**SUBSURFACE WASTEWATER DISPOSAL SYSTEM APPLICATION**

Town, City, Plantation <b>PORTLAND LONG ISLAND HARBOR</b>		Street, Road, Subdivision <b>GRACE ST 100-C-PT 2,3</b>		Owners Name <b>EDWARD NICKERSON</b>	
SITE PLAN				SITE LOCATION PLAN (Attach)	
Scale 1" = <u>100</u> Ft.

BUILDING PERMIT REPORT

Your application to construct a single family dwelling (cottage for summer use only) has been reviewed and a building permit is herewith issued subject to the following requirements:

## SUBSURFACE WASTEWATER DISPOSAL PLAN

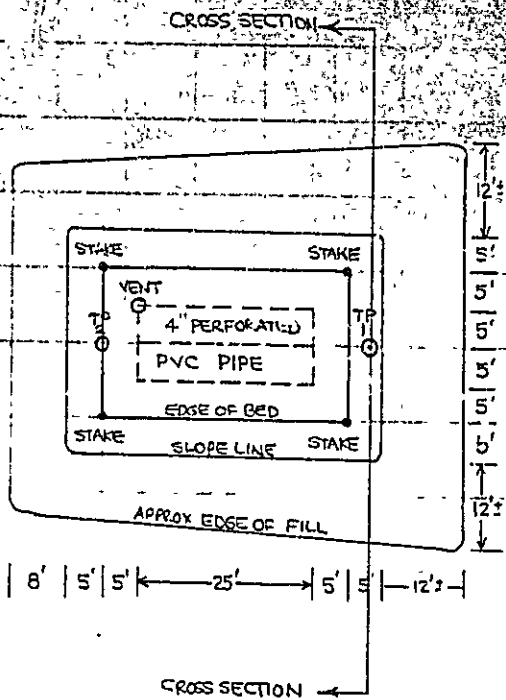
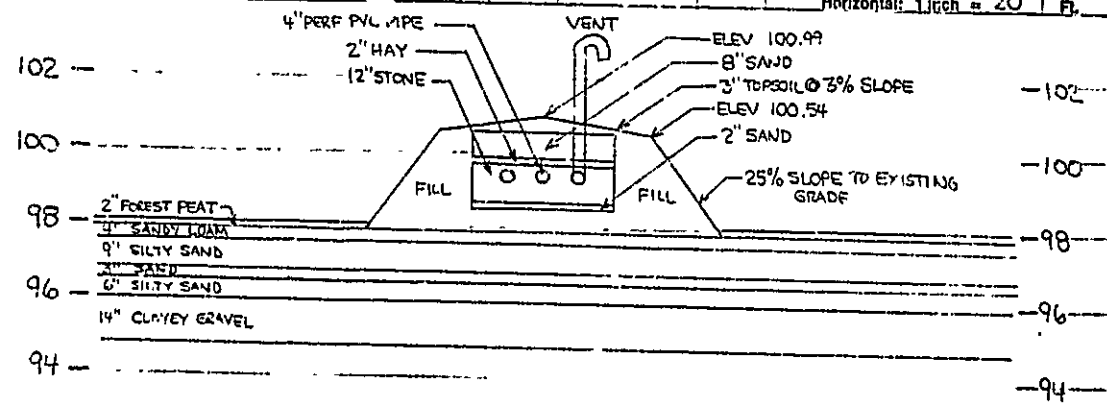
Please check on this septic  
disposal system proposal

Don't they need soil test results?

Warren he has a site or plan made  
but must submit a copy of same.  
when applying for Brady Bond
